2005 6.0L DIT RUNNING CHANGES

VGT Control Valve Connector

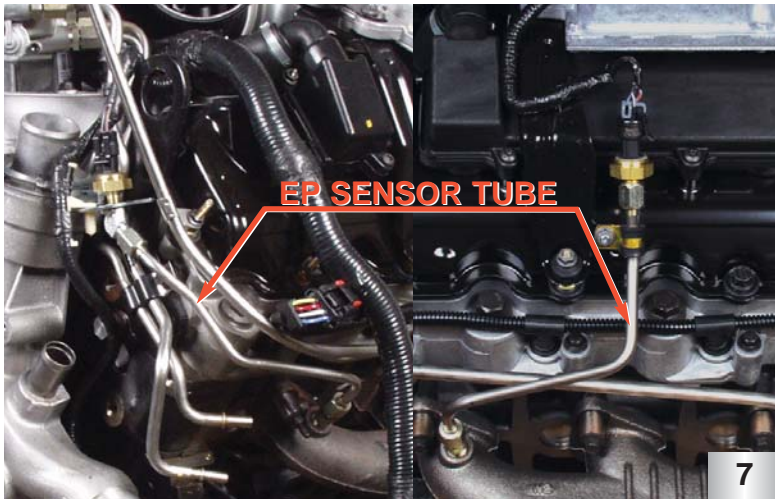
- The engine sensor harness has received several changes during the 2005 MY. Most of the changes have been made to reduce chafe points and provide more secure connections.
- One noticeable change is a new VGT control valve connector.
- The new connector will provide a more secure connection to the VGT control valve.
- **NOTE: The VGT control valve did not change.**

Exhaust Pressure Sensor Relocation

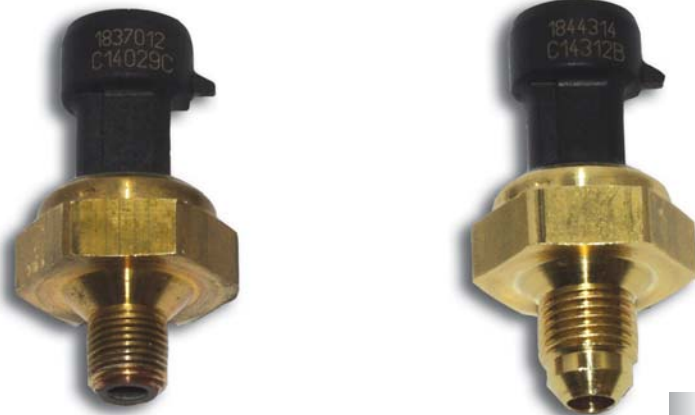
- The Exhaust Pressure (EP) sensor has been relocated to the FICM bracket.
- This change requires a new EP tube and FICM bracket to be used.
- The engine sensor harness had to be lengthened to accommodate the new sensor location.
- **NOTE: It is important to secure the nut on the EP sensor tube when removing the EP sensor.**

Water Pump Pulley

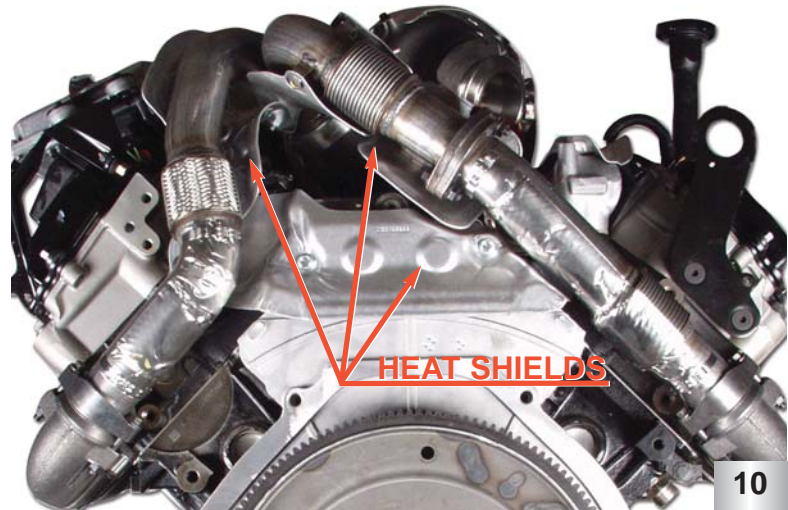
- The water pump pulley has been made more robust with the use of a thicker flange.
- The new water pump pulley design does not require the separate flange support plate as used on the previous design.

Current Style Rear Heat Shield

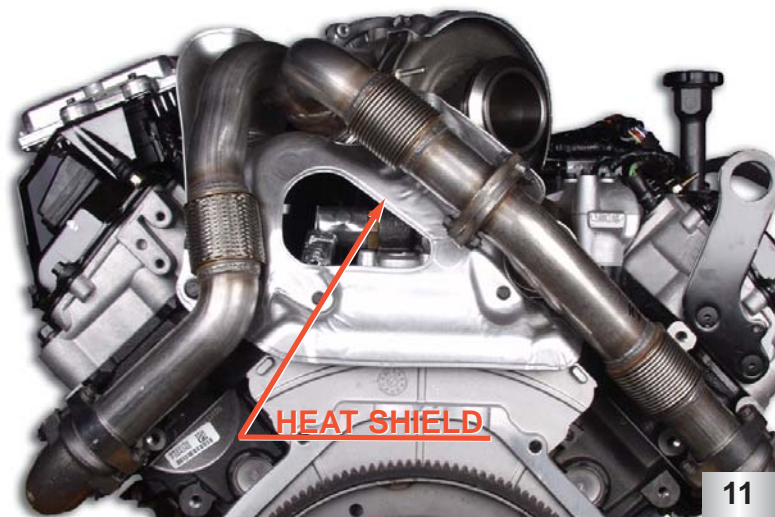
- The three heat shields on the 2003, 2004, and early 2005 MY engines have now been incorporated into one large heat shield.
- The new heat shield attaches to the high-pressure pump cover, left hand cylinder head and to the intake manifold.
